### ADDENDUM NO. 1

**Project Name:** Wadhams WWTP Improvements

Town of Westport

Addendum Date: January 12, 2021

**C-502**

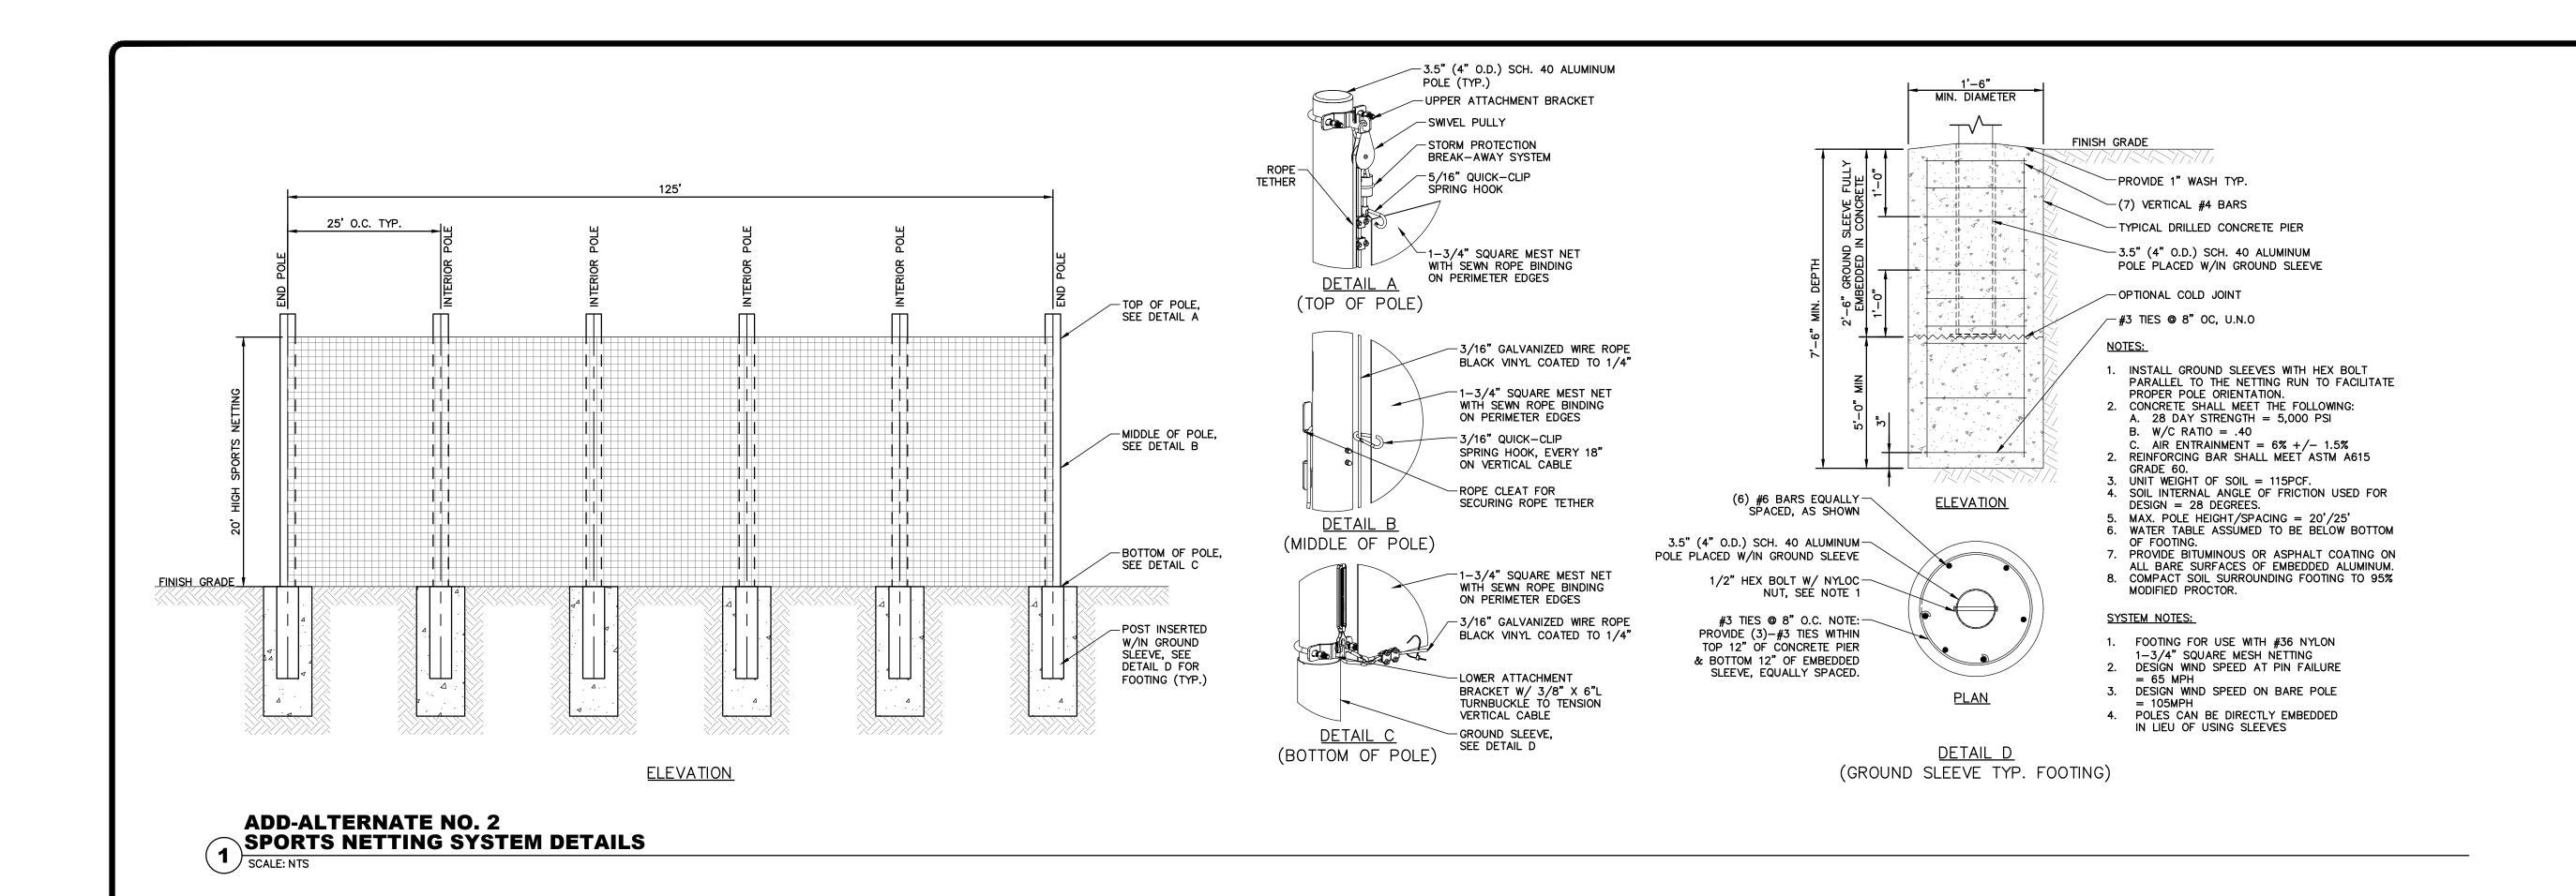
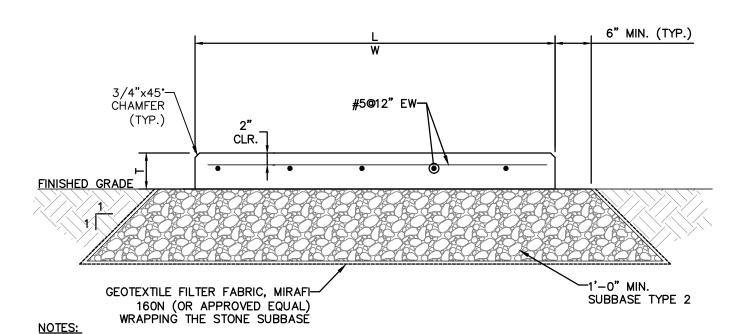
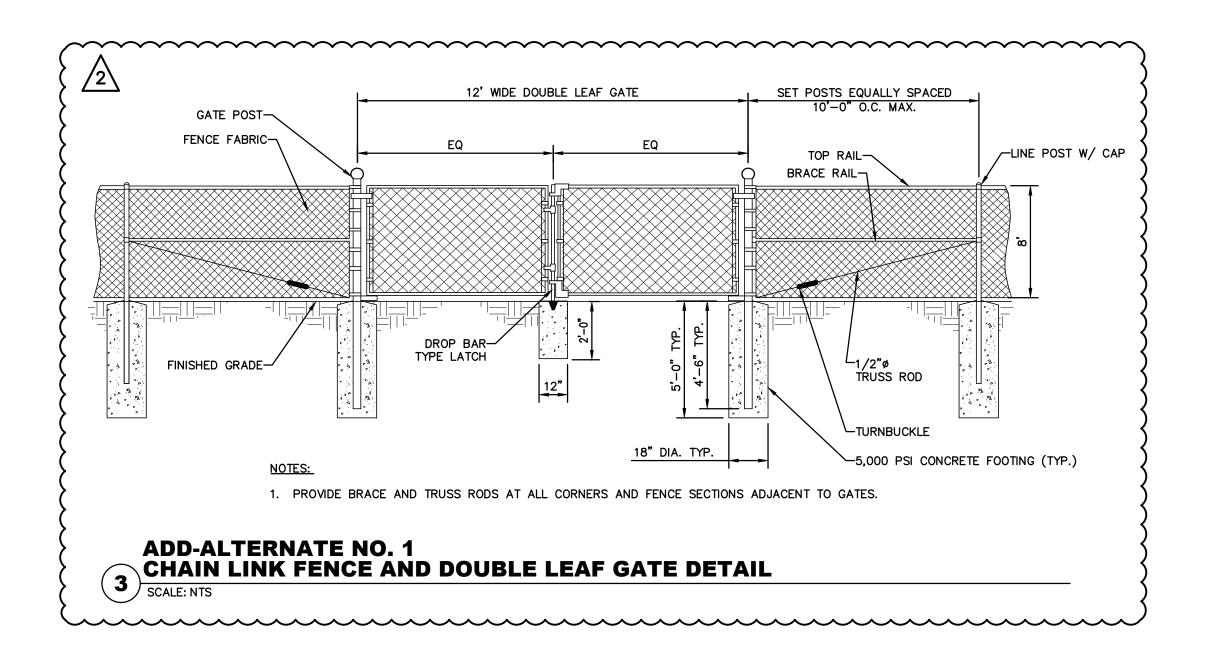
2. Q: Detail 3 on Sheet C-502 shows that the posts are to be installed 6' OC max, Chain link fence spec states that posts are to be installed 10' OC max, which is correct?

3. Q: Detail 3 on Sheet C-502 shows a bottom tension wire but the spec mentions installing a bottom rail, which is to be installed?

# 4. Q: Detail 3 on Sheet C-502 has a note that the Town is going to furnish and install the chain link fence as part of Alt No. 1, is this correct?

A: Post spacing at 10' OC max is correct. See Sheet C-502, Detail 3 which has been revised per Addendum No.1.

A: Bottom rail shall be installed. See Sheet C-502, Detail 3 which has been revised per Addendum No.1.

A: No, the note is incorrect. Contractor shall furnish and install chain link fence as part of AddAlternate No.1. See Sheet C-502, Detail 3 which has been revised per Addendum No.1.
